Access Compliance Report

Public Rights-of-Way

Intersection ID: 20172	Main Street: CORTELYOU_RD	Cross Street: FOXCROFT_RD	Location: SE
ADA ID: 7E2A3C94CDEF	Ramp Type: BlendTrans1	Initial Pass/Fail: Fail	Overall Compliance: No
		Severity Score: 12.5

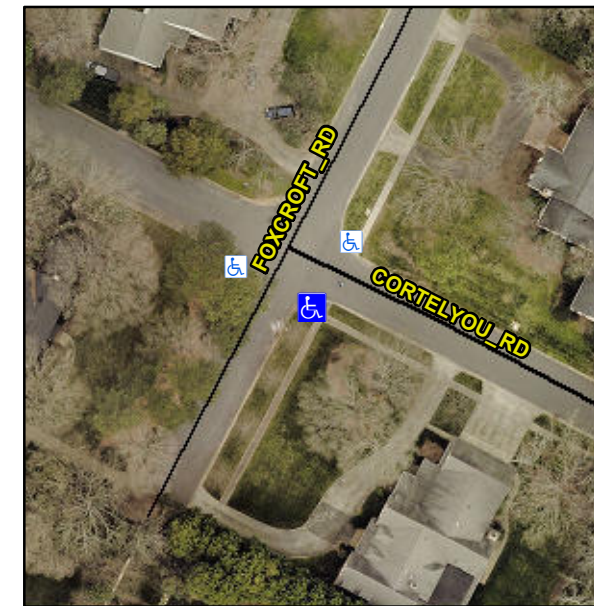
Not Found, R304.5.3

Compliance	Description	Data	Compliance	Description	Data
N/A	Ramp Length (in)	98.0	Yes	BlendTrans Slope (%)	3.5
Yes	Ramp Width (in)	48.0	No	BlendTrans XSlope (%)	5.3
N/A	Flare Type LT	N/A	N/A	Flare Type RT	N/A
N/A	Flare Slope LT (%)	N/A	N/A	Flare Slope RT (%)	N/A
N/A	Flare Traversable LT?	N/A	N/A	Flare Traversable RT?	N/A
N/A	Landing Length (in)	N/A	N/A	DWS Provided?	N/A
N/A	Landing Width (in)	N/A	N/A	DWS Contrast?	N/A
N/A	Landing Slope (%)	N/A	N/A	DWS Length (in)	N/A
N/A	Landing X Slope (%)	N/A	N/A	DWS Full Width?	N/A
N/A	Landing Curb? (Y/N)	N/A	N/A	DWS Offset (in)	N/A
N/A	Shared Landing?	N/A			
N/A	Gutter Ponding?	N/A	N/A	Gutter Slope (%)	N/A
N/A	Gutter Lip Ht (in)	N/A	N/A	Gutter X Slope (%)	N/A
N/A	Painted X Walk1?	No	N/A	Painted X Walk2?	No
	X Walk 1 Direction	To NE		X Walk 2 Direction	To NW
	X Walk 1 Width (in)	N/A		X Walk 2 Width (in)	N/A
	X Walk 1 Slope (%)	5.5		X Walk 2 Slope (%)	0.8
	X Walk 1 X Slope (%)	0.4		X Walk 2 X Slope (%)	4.0

N/A	Ramp inside XWalk1?	N/A	N/A	Ramp inside XWalk2?	N/A
	Road Slope (%)	3.6		Clear Space?	N/A
	Road X Slope (%)	6.6	N/A	Clear Space to XWalk (in)	N/A
N/A	Any Obstructions?	N/A	N/A	Storm Grate/Utility Hazard?	N/A
	Obstruction Type			Storm Grate/Utility Type	
		N/A			N/A
			Yes	Surface Condition? (G/P)	Good
			No	Curb Slope (%)	16.7

Remove & Replace Curb Ramp With Two New Directional Ramps or Equivalent.
